Water Tank Vent/Overflow

Rob Farrow
March 2021

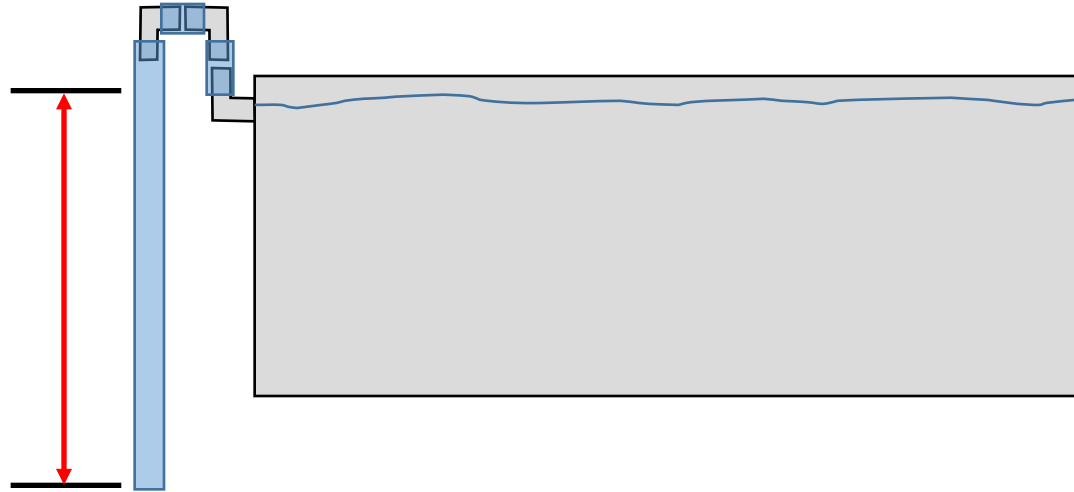
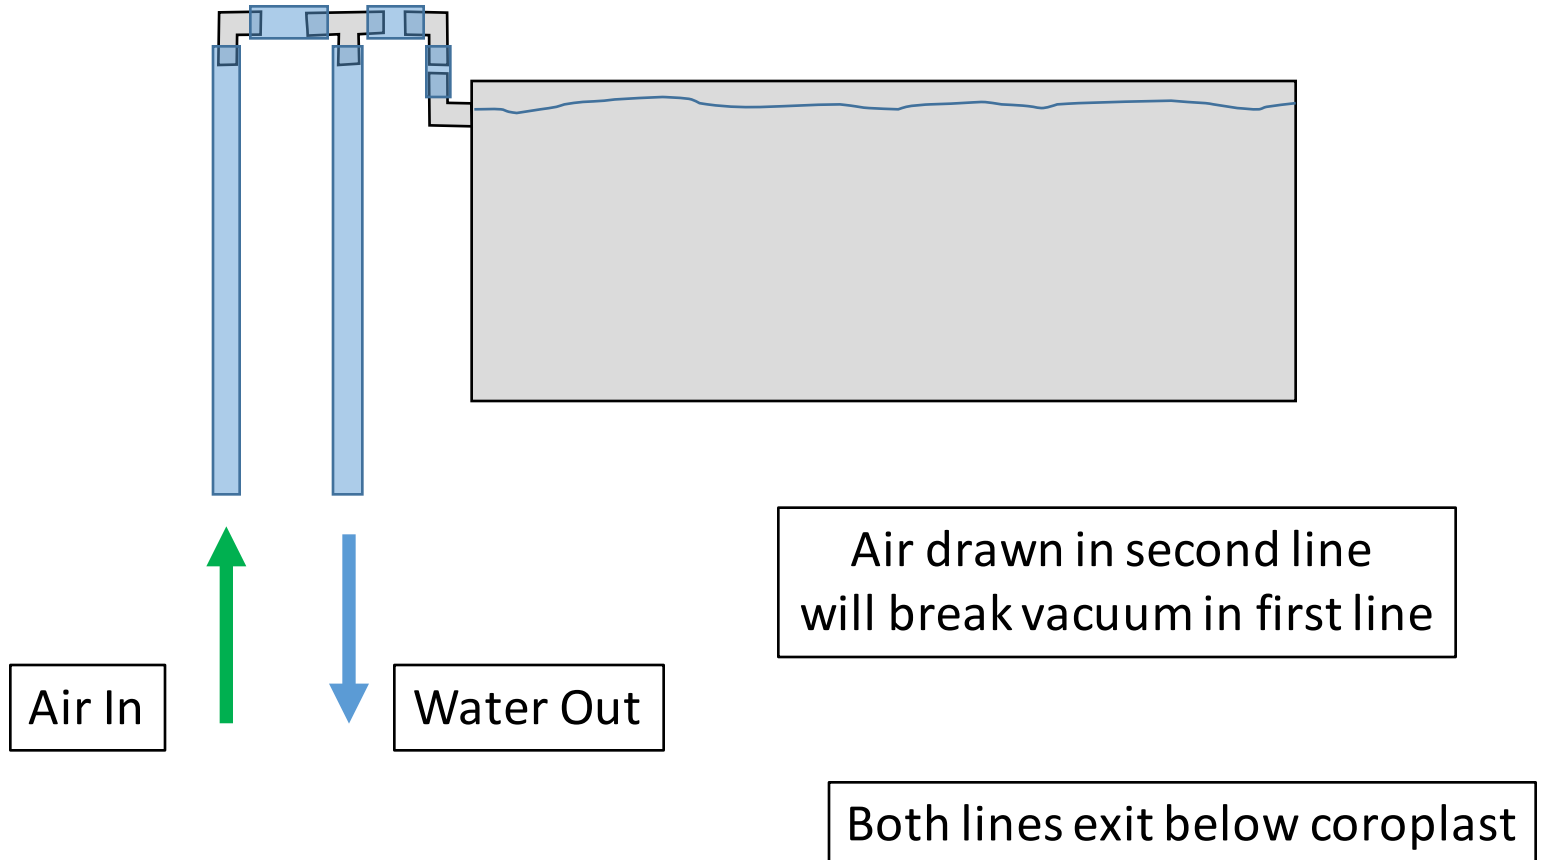
10" water column
creates sufficient
vacuum to
collapse tank

Proposed Modification

Addition of a T and a second line
will solve the problem

Air drawn in second line
will break vacuum in first line

Both lines exit below coroplast

Grand Design will
adopt this idea across
All Production
beginning May 2021

Retrofit to earlier builds
should be easy to
accomplish

Parts Required:
 $\frac{3}{4}$ " Pex Pipe
One T fitting
Four Pex Clamps
